In the drawings:

**CONTACT OPTICAL HEAD FOR DATA STORAGE**

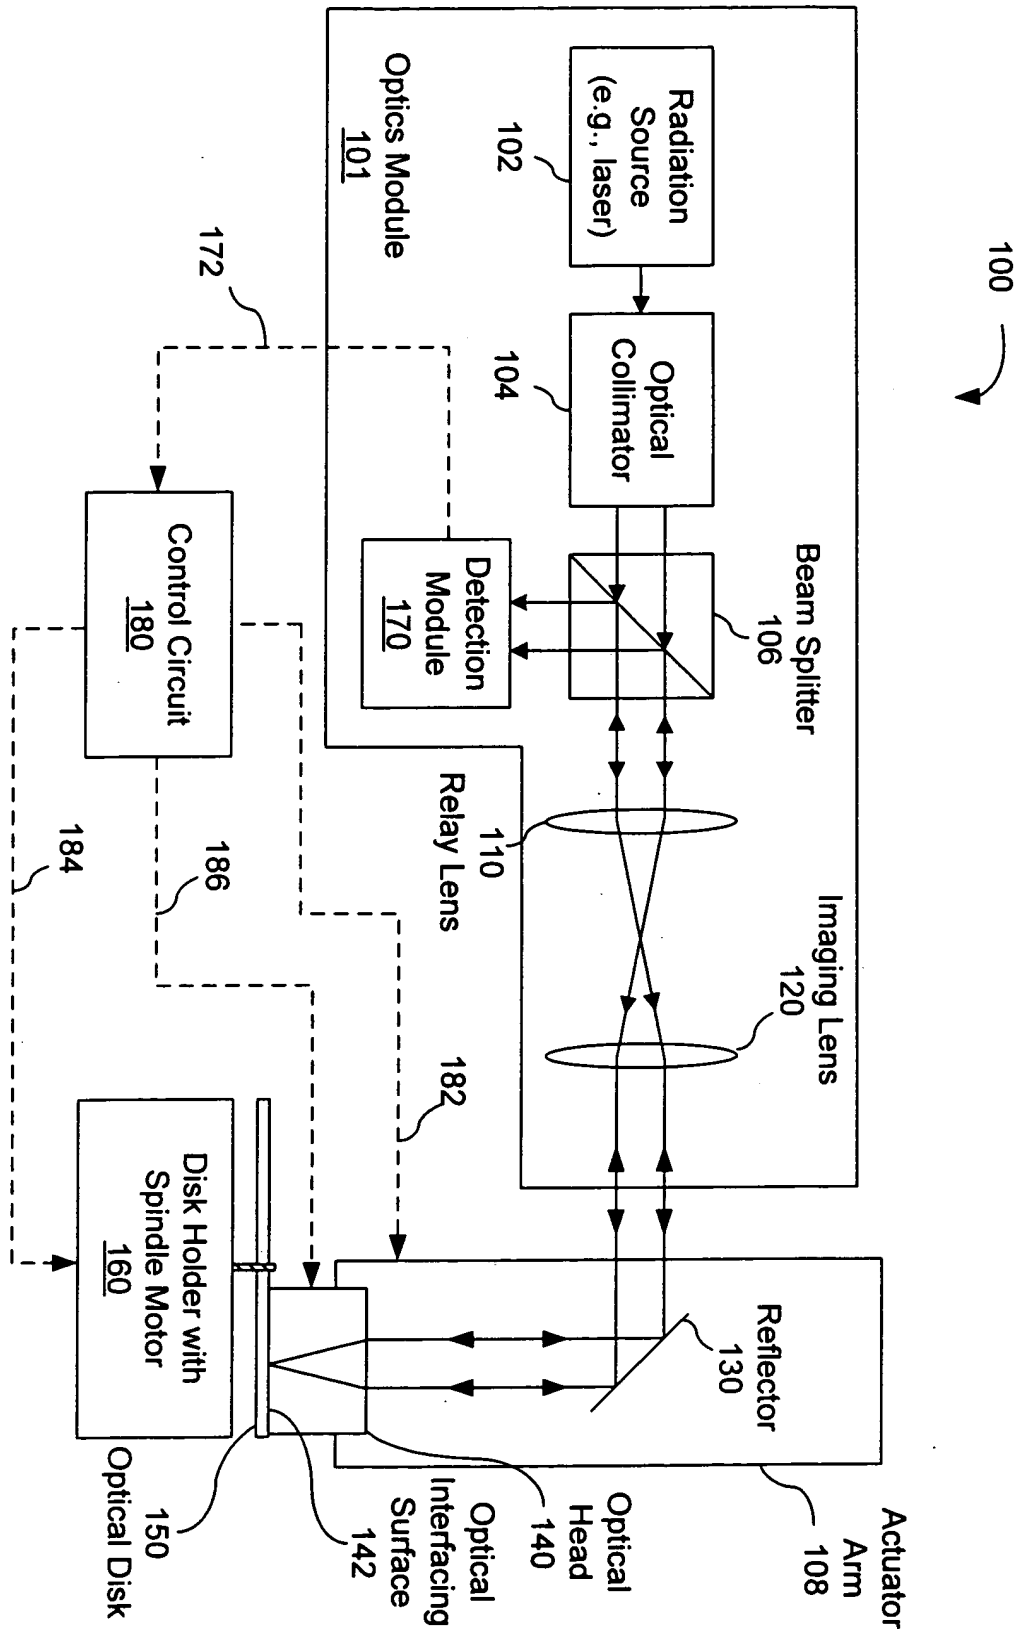
Please change the label "510" on the right end of the actuator in FIG. 5 to "520." A new set of drawings incorporating this correction is filed herewith. No new matter is added.
